INDESIT company

AQXF129EU/HA

F051370

1290110 Exploded views

n4011c00: Counterweight screws

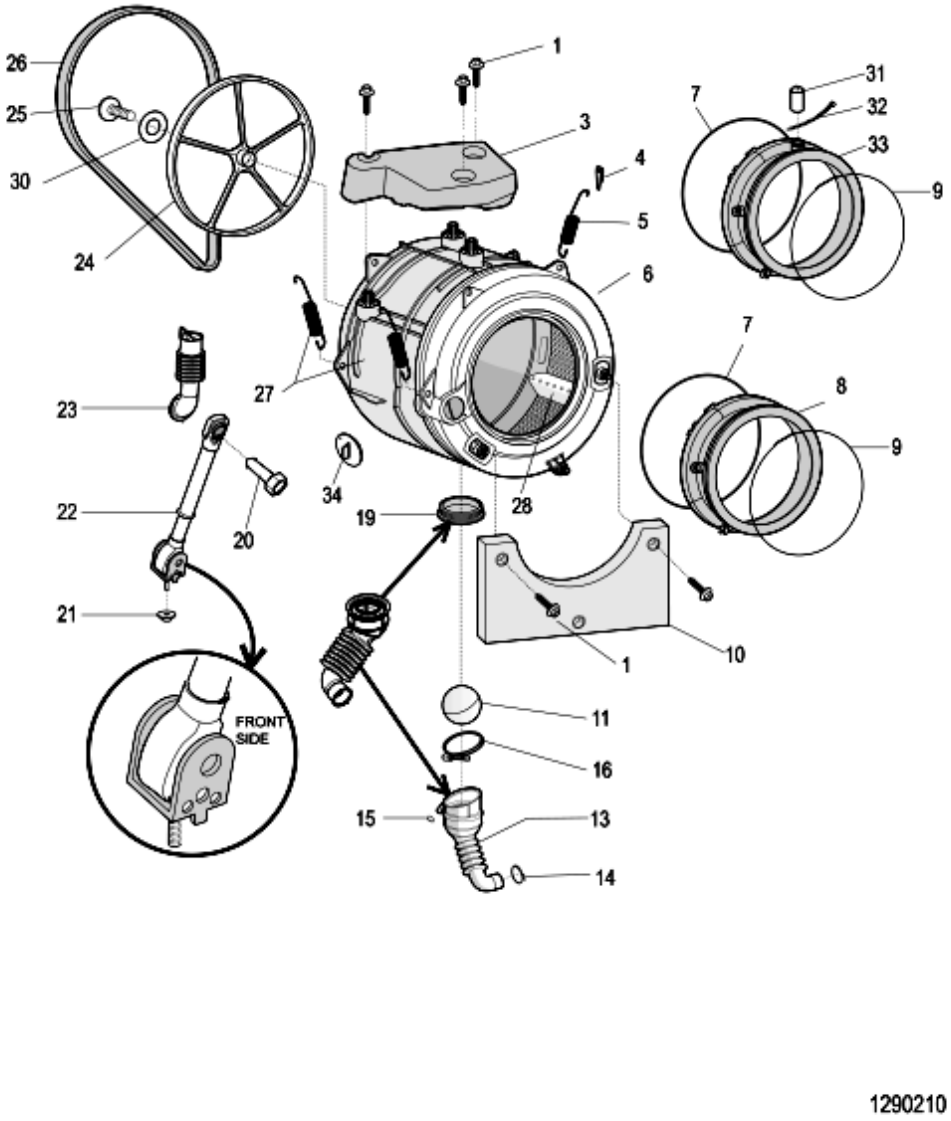
Use code C00194612 (screw with larger diameter) in case of fixing counterweight on the original plastic tub of the machine

Use code C00194611 in case of fixing counterweight on a new plastic tub used as spare part

NOTE:
When /if replacing the Plastic outer drum assembly ensure the correct counterweight screws are used.

n4008f00: Thermic link wire removed on three-phase motor

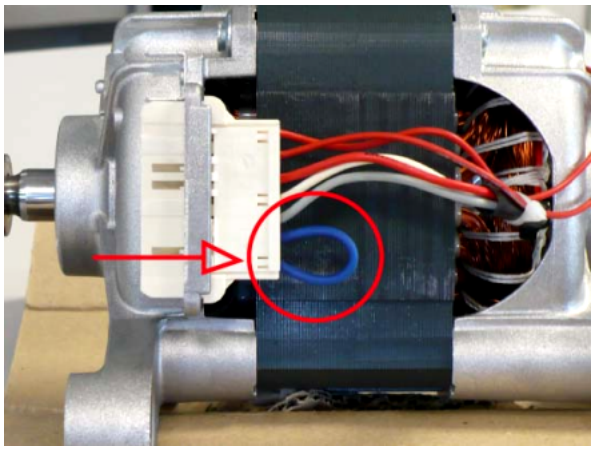
Attention!
When you assist the premodification models using the new motor code you MUST use the thermic link wire code C00265838.

The spare part warehouses will manage the premodification motor until the end of the stock, after they will be replaced with new ones and thermic link wire.

TRIPHASE P40 46 L – INOX TUB
C00265827 new motor without thermic link wire - C00116103 premodification motor with thermic link wire

TRIPHASE P40 46 L – PLASTIC TUB
C00265826 new motor without thermic link wire - C00142390 premodification motor with thermic link wire

TRIPHASE P50 52 L
C00265829 new motor without thermic link wire - C00142205 premodification motor with thermic link wire

TRIPHASE P32 46 L TOP LOADING
C00265832 new motor without thermic link wire - C00262375 premodification motor with thermic link wire

TRIPHASE P40 46 L TOP LOADING
C00265834 nuovo new motor without thermic link wire - C00112739 premodification motor with thermic link wire

In the attached image you can see the fixing of thermic link wire in the motor therminal box.
